CHESTNUT LODGE PROJECT
PRU Exploratory Application No. PRU2005-00022

SUBJECT: HDC Review Comments on Chestnut Lodge Exploratory Plan

EXPLORATORY APPLICATION COVER SHEET

STREETSCAPE SECTION

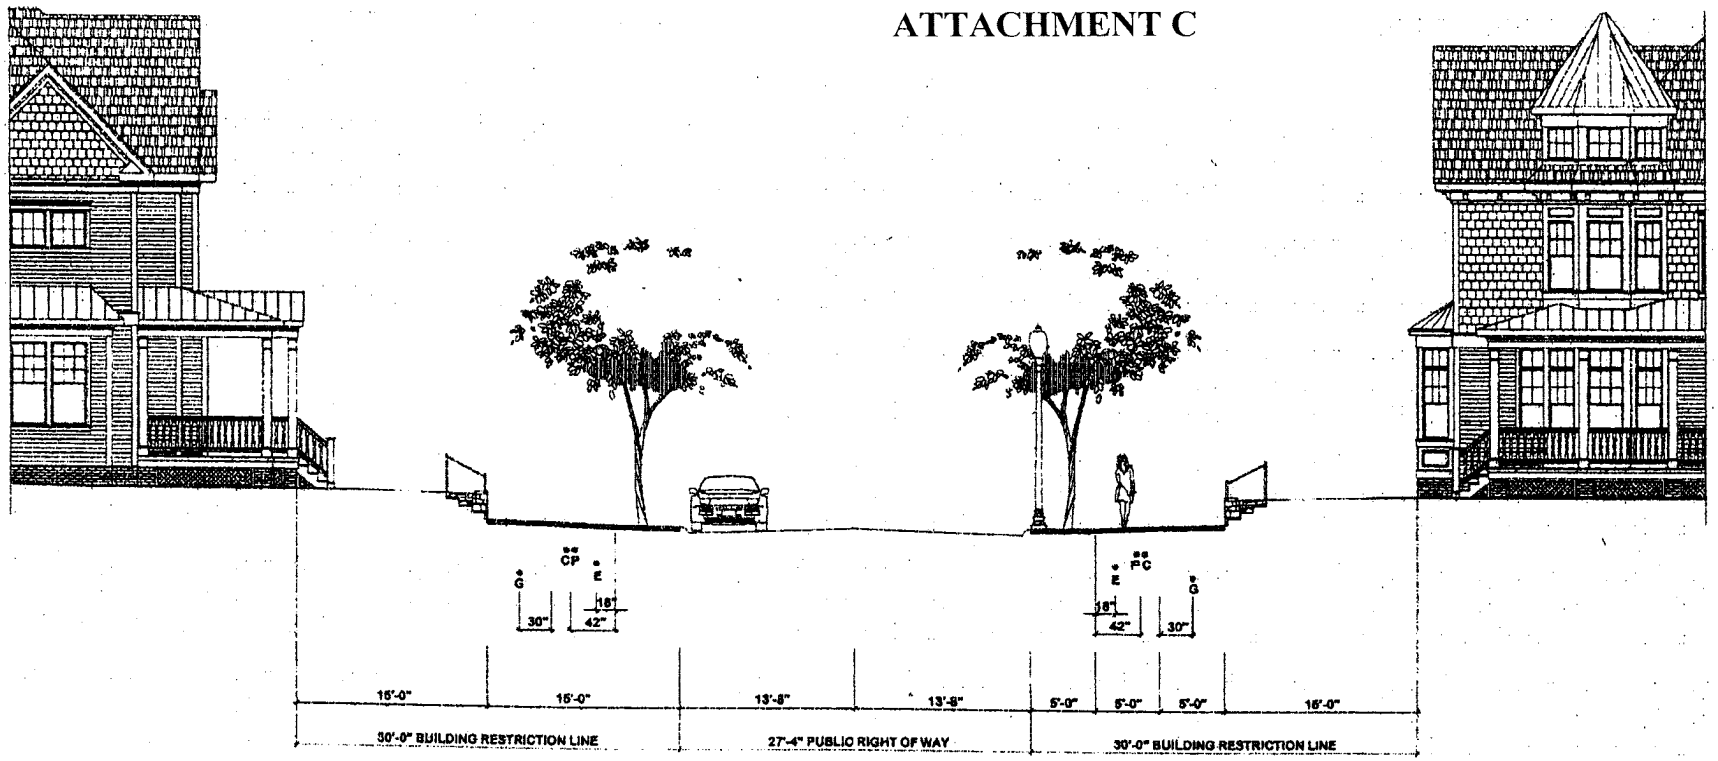
- The public street in the single family portion of the property will be within a 27 foot 4 inch wide right-of-way and provide 26 feet of paving. Outside the public right-of-way, the Application proposes two typical sections. The first proposes a five foot wide planting strip (measured from the rear of the proposed curb), a five foot wide brick paver sidewalk, and an additional 5 foot planting strip will contain the gas line. These areas and improvements will be subject to a utility and maintenance easement, PUE. The second typical section pertains to lots inside the street loop. The Application proposes to provide a 15 foot planting strip (measured from the rear of the proposed curb) which will be subject to the PUE and the gas and maintenance easement. A five by eight foot brick paver pad will be installed behind the curb to provide a landing for the lead walks to and from the homes. A two to three foot high landscape stone wall will be constructed on each of the lots adjacent to, but outside the 15 foot PUE. Standardized mail boxes will be placed at the curb for all houses. A rear alley will provide access to garages on lots 2 through 7 and will consist of 15 feet of pavement. The alley will be located within a 17 foot easement on the lots and will be maintained by the HOA.

TYPICAL 27'-4" R/W SECTION C-C
NOT TO SCALE

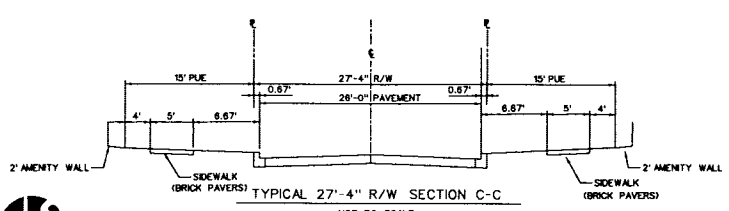
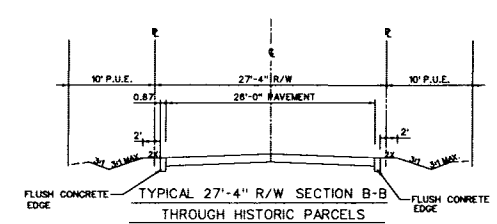
1. To allow a reduced right-of-way width from 60 feet to 27 feet, 4 inches for a secondary road, measured from back of curb to back of curb.

2. To allow a flushed concrete edge along the road within the Historic District area, instead of standard curb and gutter, in order to preserve as many existing trees on the site as possible.

The HDC recommends a modified curb design for the new road within the historic district that would be more sensitive to the historic setting than a typical curb and gutter configuration. Substantial landscaping along this new road is not recommended if it would further block views of the Lodge and Frieda's Cottage from West Montgomery Avenue and Thomas Street.
